**Validation Report
Local Centre Blocks B + D**

North Stoneham Park, Eastleigh, SO50 9RH

April 2023

From: Tim Mitchell
Sent: 17 April 2023 15:27
To: Olivia Maxwell
Subject: Fw: Pollution comment - Land Contamination Validation Report for Stoneham local centre DC/23/94492

Date 12.12.19
Drawn By/Checked By AST/AST
Scale 1:10@A3
Revision C1
Project Stoneham Local Centre
Title Typical Block D Separating Wall Sleeper Wall Detail
Dwg # 19.024_HGP_BB_00_DR_A_811

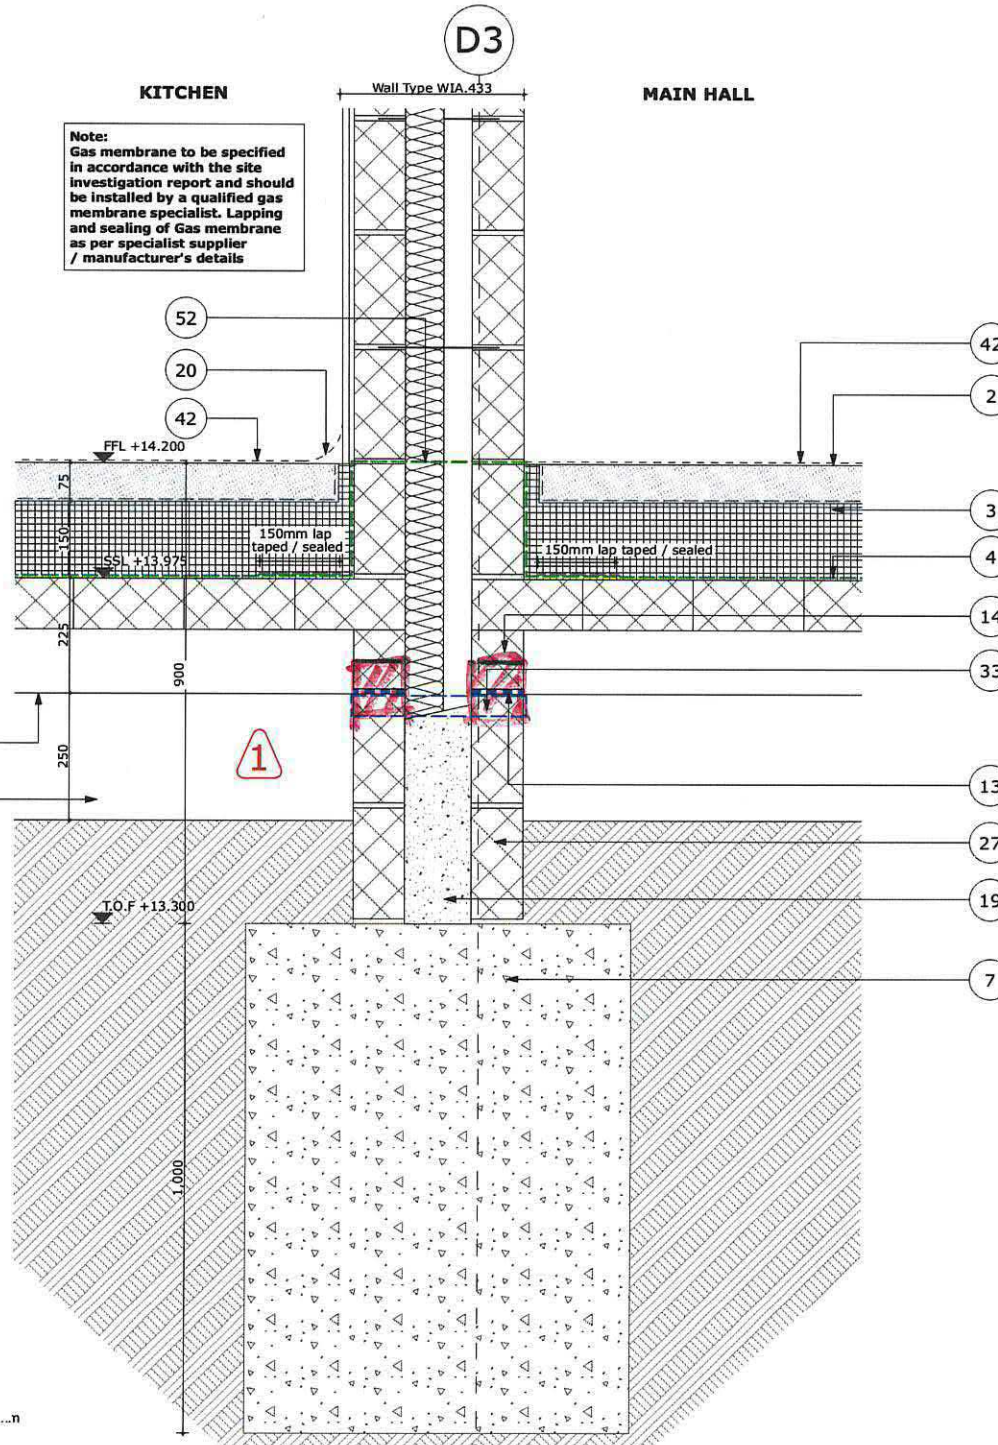
I've looked at the Ramboll RMS, and whilst it has some details on the gas protection measures, particularly in respect of the membrane, it falls short of being a site specific scheme, the plans included below would have sat well within such a site specific RMS had one been drawn up, and given the large building footprint this has led to some issues.

The plans provided recently show a proposed: 250mm sub floor void, and ventilation of 1500mm² / metre run of wall, with cross ventilation across internal subfloor walls. The building dimension exceeds 15 metres.

I was a little concerned that we have jumped to the worst-case conclusion, and I would have appreciated a phone call or further with Neil to review this. However, on revaluation of the submission I have noticed that Neil would have reviewed the HGP detail 811 Sleeper wall details and seen that the ventilator notes shown would lead to this query.

I am more than happy to point out the detailed design progressed with advice from the gas membrane specialist and thus improving the substructure cross ventilation providing more than the external wall ventilation rate and more than achieving the very good criteria. See marked detail and photos to confirm installation and that the cross-void ventilation was the total opening without a proprietary ventilator (only needed to external façade) thus being 240x95 achieving 22,800mm² per vent with locations already confirmed on the previous submission. As you already know with full height doors & windows sometimes it hard to achieve a standard set spacing of vents so oversupplying free area per vent can be critical, which has been done here on both blocks.

I would dearly like to receive the approval of condition as soon as possible. I will be asking HGP to issue an as built detail and Omnia (staff on leave) to update the report for completeness however the approval could be issued on this email chain and photo evidence.
